Responses to Reviewer Comments on “Effect of tip spacing, thrust coefficient and turbine spacing in multi-rotor wind turbines and farms”

Niranjan S. Ghaisas, Aditya S. Ghate, Sanjiva K. Lele

1 Response to Reviewer 1

Figure 1: Added turbulence intensity ΔI_{disk} for isolated 1-rotor and 4-rotor turbines with varying tip spacings denoted in the label, for $C_T' = 4/3$.

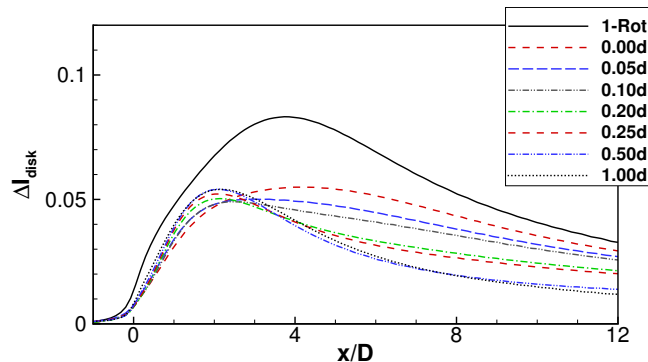
When I looked at the integrated added wake turbulence intensity, I found that the four-rotor wind turbine has a higher integrated added wake turbulence intensity in the near wake compared single-rotor wind turbine, while the opposite is found for the far wake, see Figure 18 in van der Laan et al. (2019).

Response: This is an interesting observation, that is not reproduced in our LES. It should be noted that the quantities plotted in our Fig. 6c and in Figs. 18(b,d,f) in van der Laan et al. (2019) are different. For a fair comparison between the two sets of results, the disk-averaged added turbulence intensity, defined as

is plotted in Figure 1. The subscript ‘disk’ denotes disk-average and the subscript ‘0’ denotes upstream region, or the region between $x/D = -4$ to $x/D = -1$ in our simulations, where the quantities are almost constant. This measure of added turbulence intensity is compared to Figs. 18(b,d,f) of van der Laan et al. (2019).

It is seen that ΔI_{disk} for all the 4-rotor cases is always smaller than for the 1-rotor case. The qualitative differences between the near-wake and far-wake regions are not observed in our LES results. A closer examination of the results in van der Laan et al. (2019) suggests that ΔI_{disk} is larger for the 4-rotor case in the near-wake region only for $I_{ref} = 5\%$ and 10% , but not for $I_{ref} = 20\%$. Thus, our results may be considered to be qualitatively similar to the results of van der Laan et al. (2019) for $I_{ref} = 20\%$. It is difficult to gauge the accuracy of one LES with another LES as a benchmark, so we refrain from commenting on which LES result is more accurate. This information is included in Fig. 6(d) of the revised manuscript and in Section 3.2 (lines 218-224).

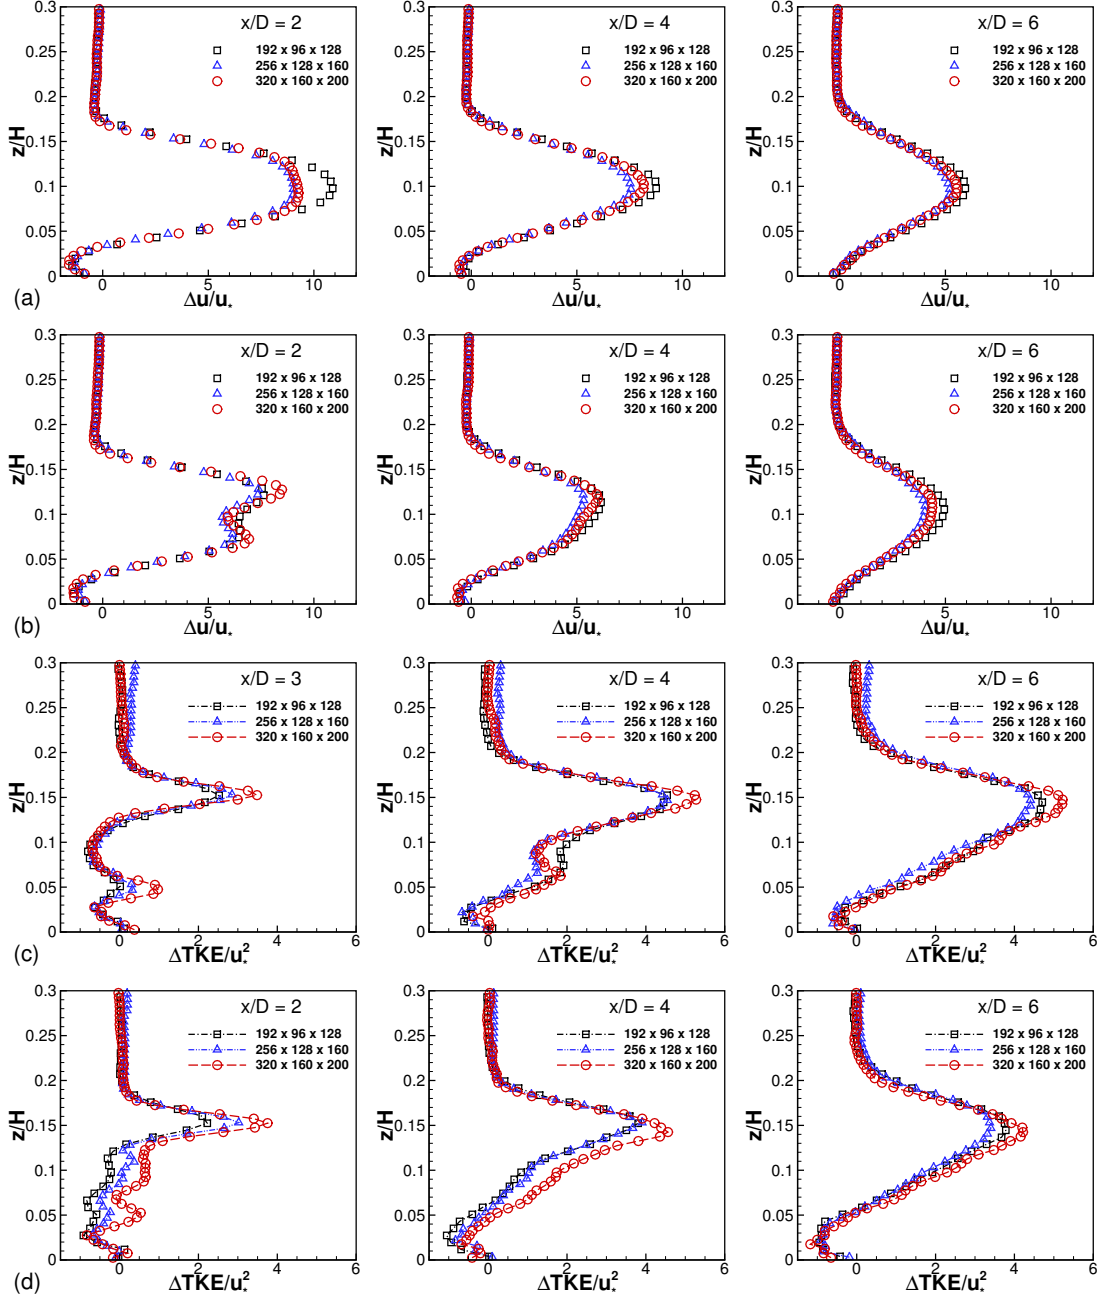
- p. 8, Fig. 3: *Please be consistent in plotting. The linewidth in the symbols change from left to right, i.e. symbols are less clear.*

Response: The symbol linewidths are now uniform.

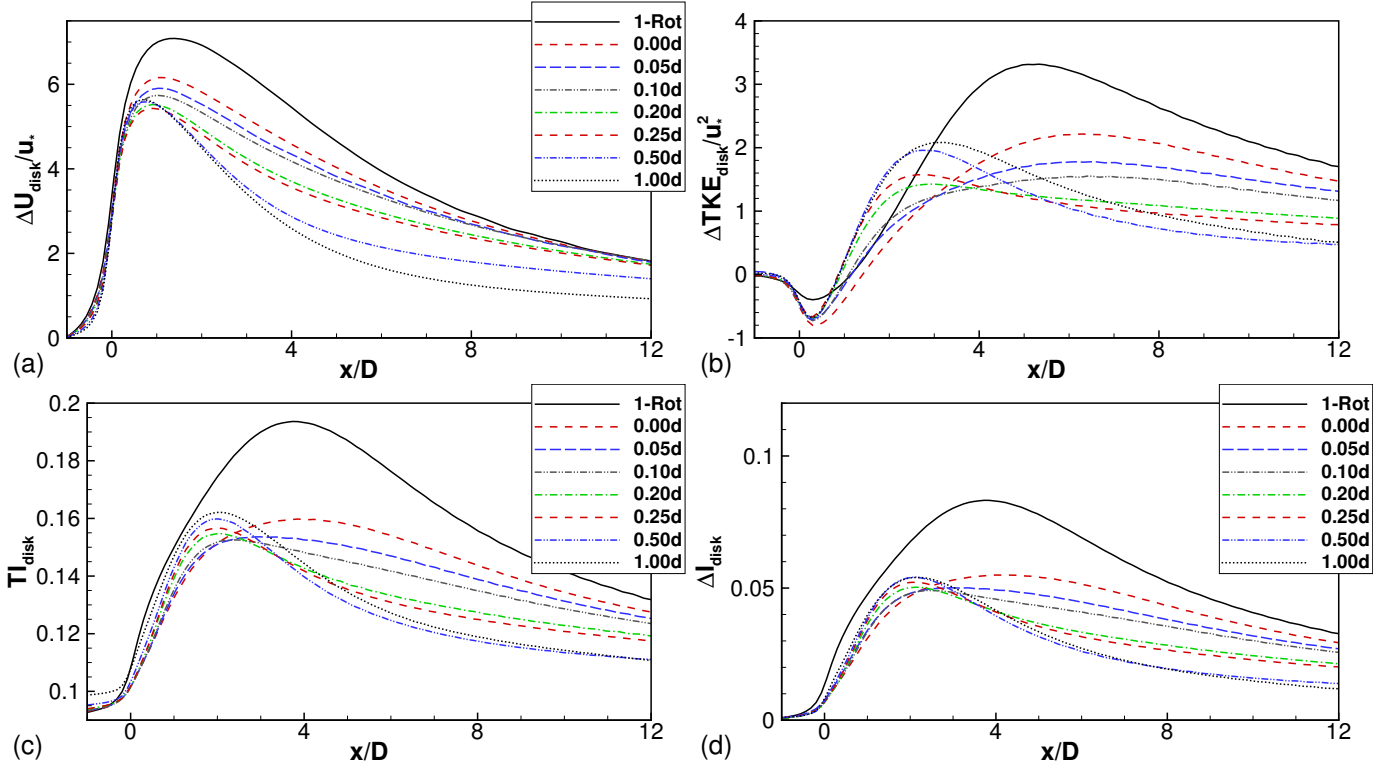
5. *Figure 6c: The single-rotor wind turbine seems to have a much higher disk averaged ambient turbulence intensity. Why is this the case?*

Response: We appreciate the reviewer’s eye for detail. The larger ambient turbulence intensity seen in Fig. 6c actually corresponds to the 4-Rotor $s/d = 1$ case. We apologize for the confusion: the line styles chosen for the 1-Rotor and 4-rotor $s/d = 1$ cases were very similar to each other. In the updated manuscript, a different line style has been used for the $s/d = 1$ case.

It should be noted that the integrals are carried out over different regions corresponding to the areas spanned by the rotors in the different cases. Thus, the ambient TI_{disk} values are slightly different for all cases. The differences are apparent on the scale of the figure only for the $s/d = 1$ case, which is why it appears to be an outlier.

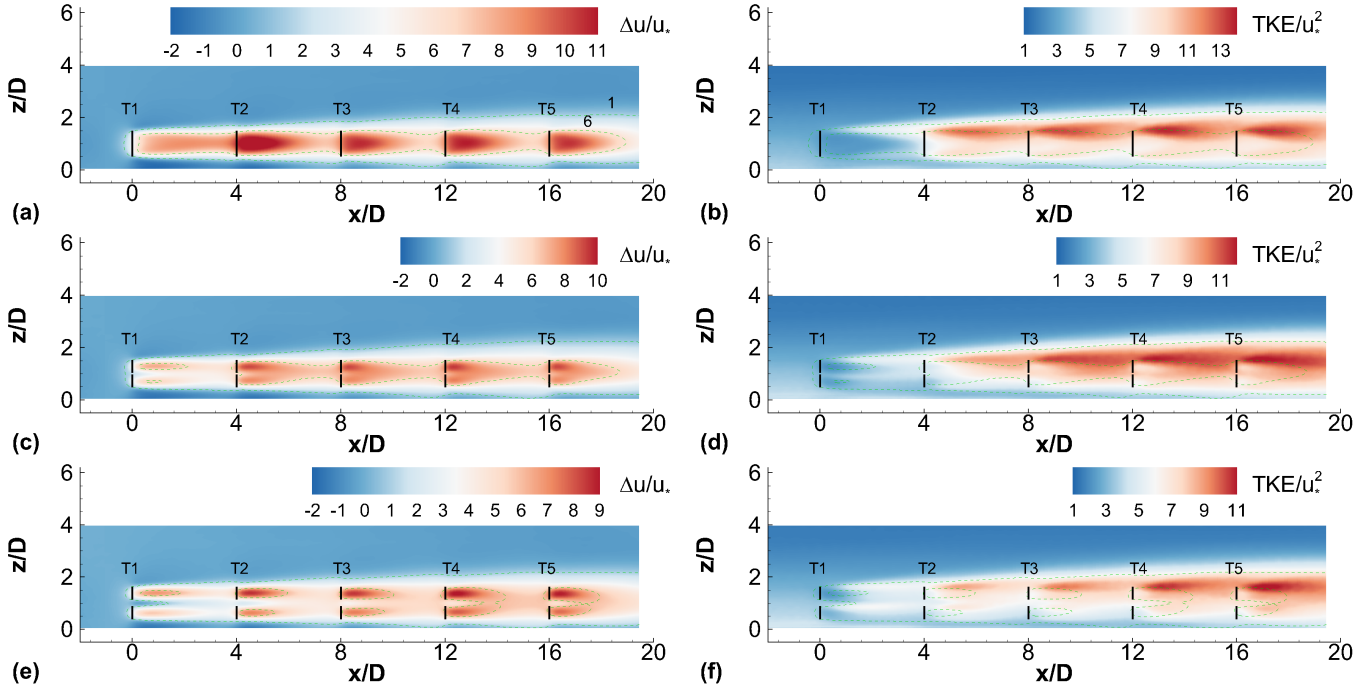
5. Figure 8: There are additional numbers plotted in Figure 8a.

Response: These numbers are included in Figure 8a (as well as in Figure 4a) deliberately, so as to draw attention to specific contour levels, as explained in the figure caption.

Figure 10. Disk-averaged (a) velocity deficit and (b) turbulence intensity, and (c) relative power for 1-rotor and 4-rotor wind farms with $S_x = 4D$ and varying thrust coefficient. Legend denotes the pair $(s/d, C'_T)$.

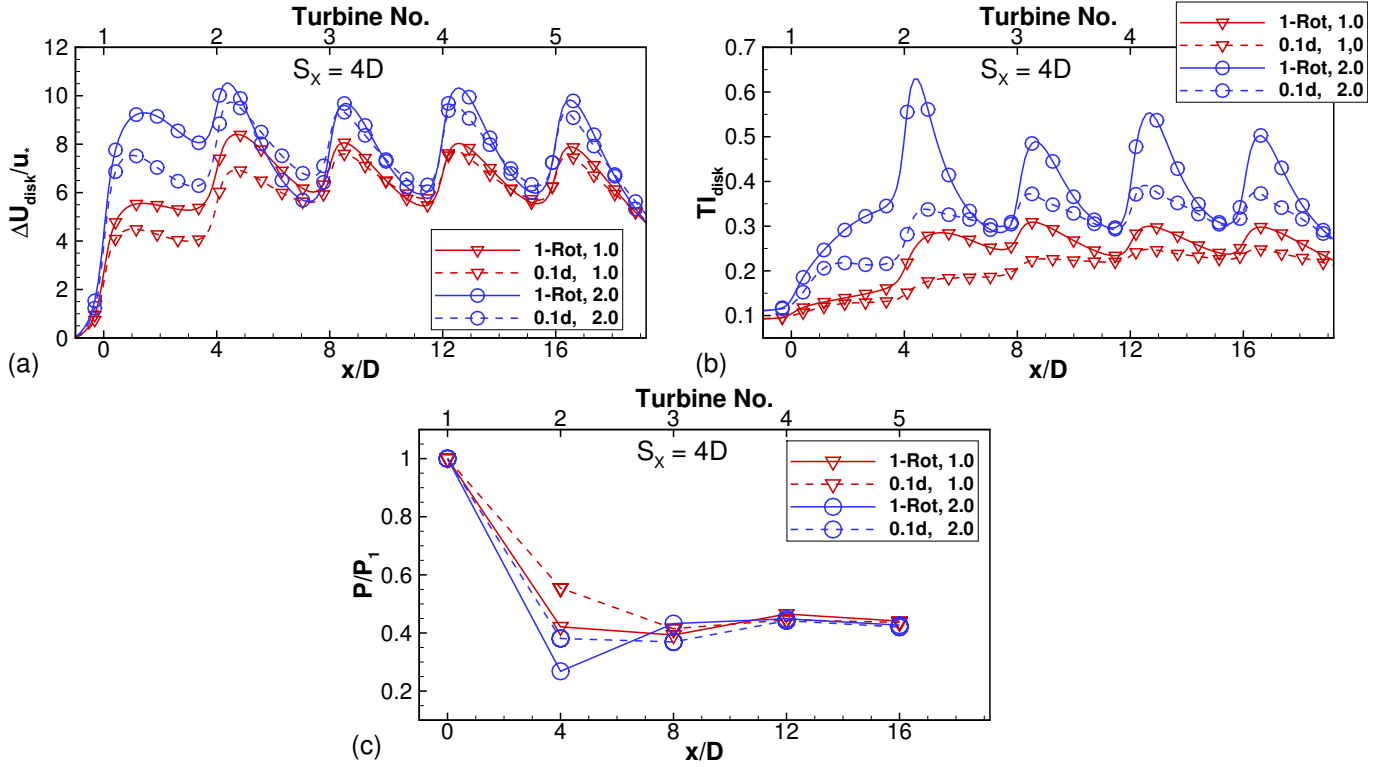
- p. 15, line 268-270: *The authors state "It is seen that P2-5 is larger for all 4-rotor wind farms...". This is not correct. If you look at Figure 10(c) there is actually a cross-over for the 3rd turbine, where the single rotor produces more. Be careful, when you do the aggregate statistics, because it gets lost. Please rephrase.*

- p. 17, Fig. 10: Please improve the figure. It is very difficult(impossible) to tell the lines apart as the symbols are so large that they cover the full vs broken lines. Comment on the cross-over at the 3rd turbine.

Response: In Fig. 11 and the accompanying discussion, we talk about average of the relative powers of turbines 2 through 5 (aggregate statistics) and not individual turbine powers. The individual relative power values, and whether they are smaller or larger in the 4-rotor wind farms compared to the 1-rotor wind farms, have already been presented prior to this in Figs. 9 and 10 and associated discussion (lines 246-296), so we do not repeat the same observations here.

Response: The figure has been modified. The differences between the lines are hopefully clear now. Comments on the crossover are added to Sec. 4.2 (lines 293-296).

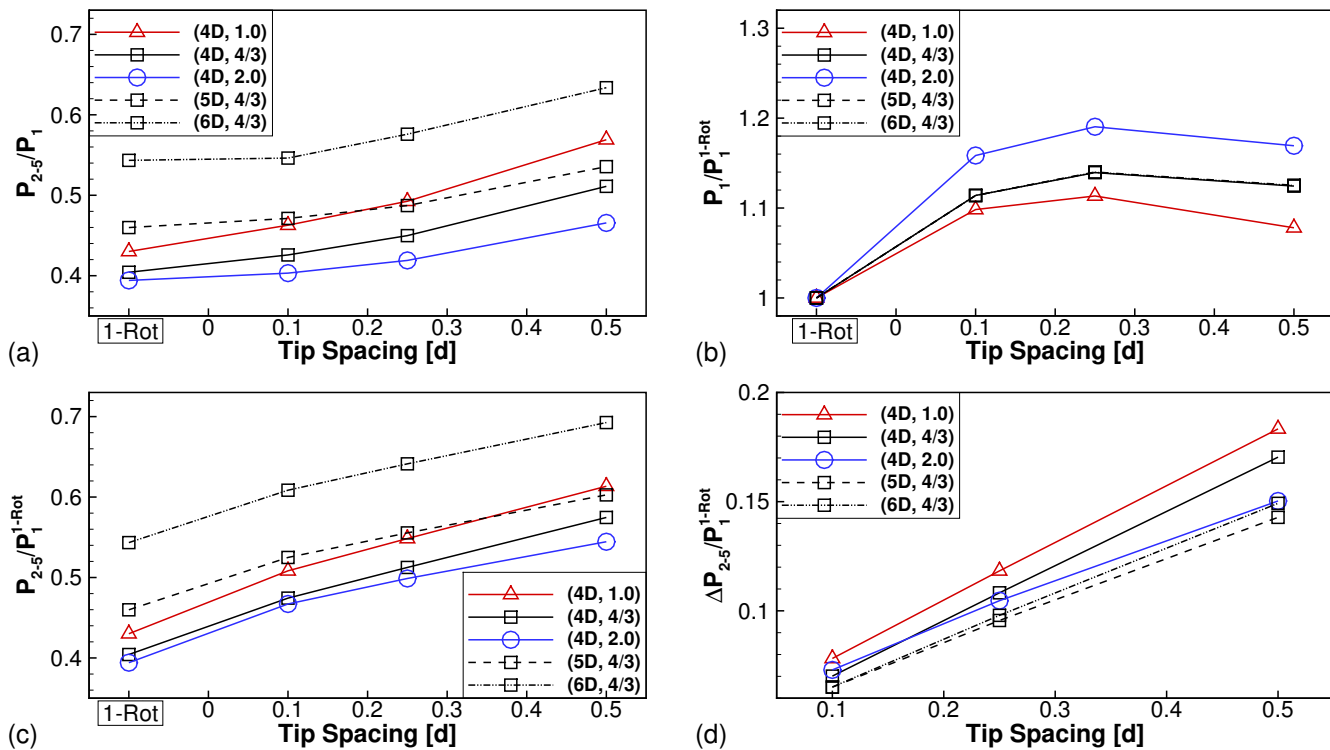
- p. 18, Fig. 11(b): Only three lines are visible. Please explain/comment in the text.

Response: Three of the lines, corresponding to fixed $C'_T = 4/3$ and varying $S_X = 4D, 5D$ and $6D$, lie on top of each other. This is included in the revised manuscript (lines 305-306).

Figure 13. LES results and model predictions of (a) disk-averaged velocity deficit and (b) relative power for 1-rotor wind farm with $S_X = 4D$ and $C'_T = 4/3$. (c,d) Corresponding results for 4-rotor wind farm with $s = 0.1d$.

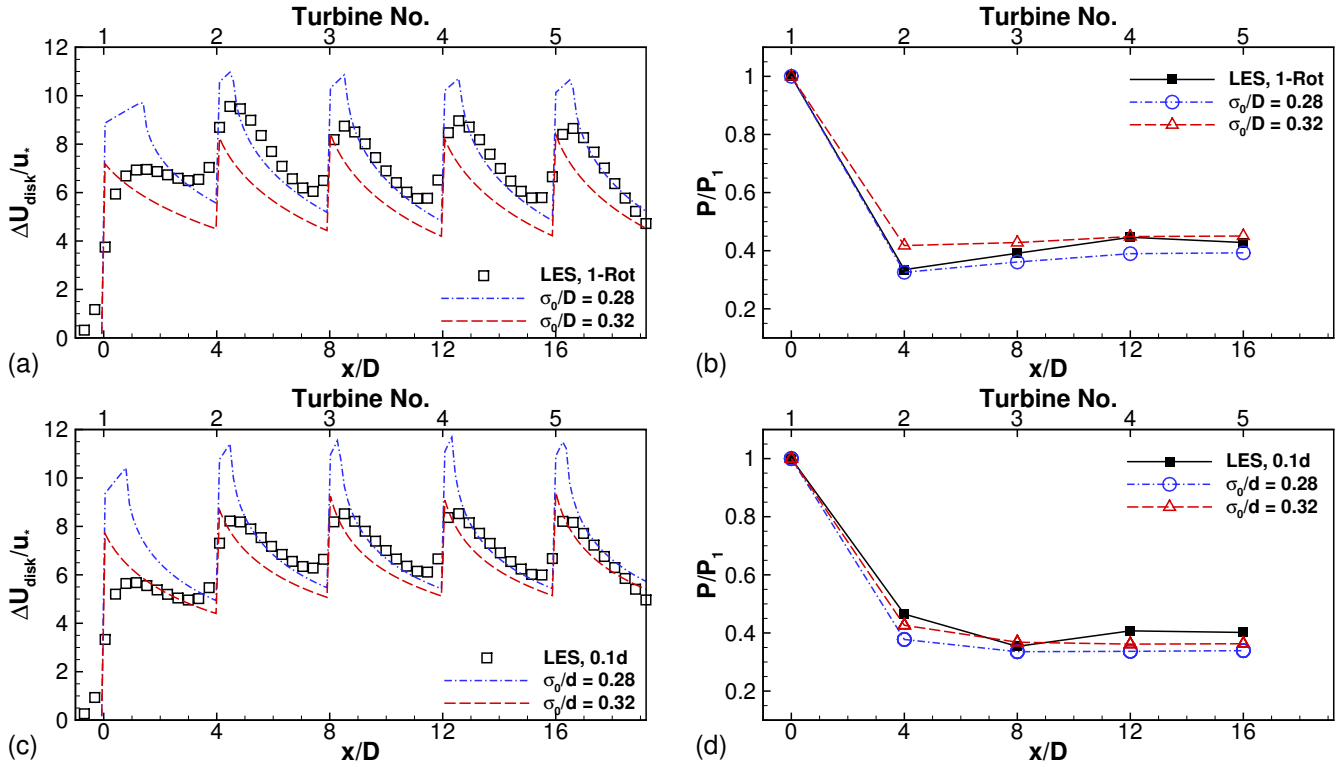
5. *Analytical Model - The text in p. 19, line 310-313 does not seem to match Fig. 13: "Fig. 13(b) also show a similar sensitivity to the value of sigma"? It appears that sigma=0.28 gives better results for the velocity deficit, but worse for the power. Please explain this, because power should be proportional to U^3 .*

Response: The point we wanted to make here was that $\sigma_0/D = 0.28$ gives better results for the velocity deficit only in the region approximately $1D - 3D$ downstream of each turbine, but not close to the turbine. $\sigma_0/D = 0.32$ gives better prediction closer to the turbine. Thus, better modeling of the region at and close to the turbine is important for predicting power. We have reworded the paragraph to hopefully make these points more clear.

Figure 14. LES results and model predictions of relative power using spatially constant k_* for (a) 1-rotor wind farm and (b) 4-rotor $s/d = 0.1$ wind farm with $S_X = 4D$ and $C'_T = 4/3$.

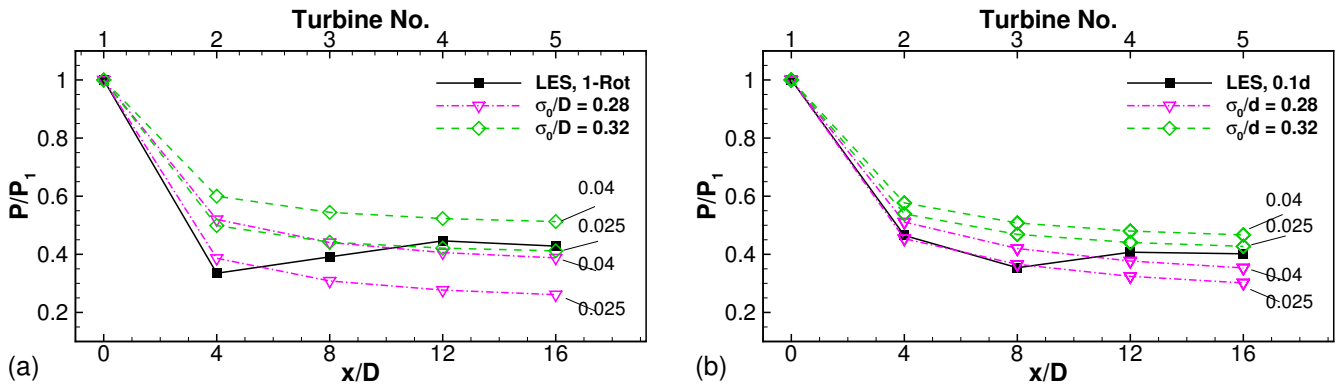
(d) How large are the differences between the wake model and LES if you had used a constant k_ ? This is a relevant question because it is the standard usage of the chosen wake model.*

Response: Please see response to point 6(a) above and the revised manuscript (Figure 14; Sec. 4.3, lines 358-371).
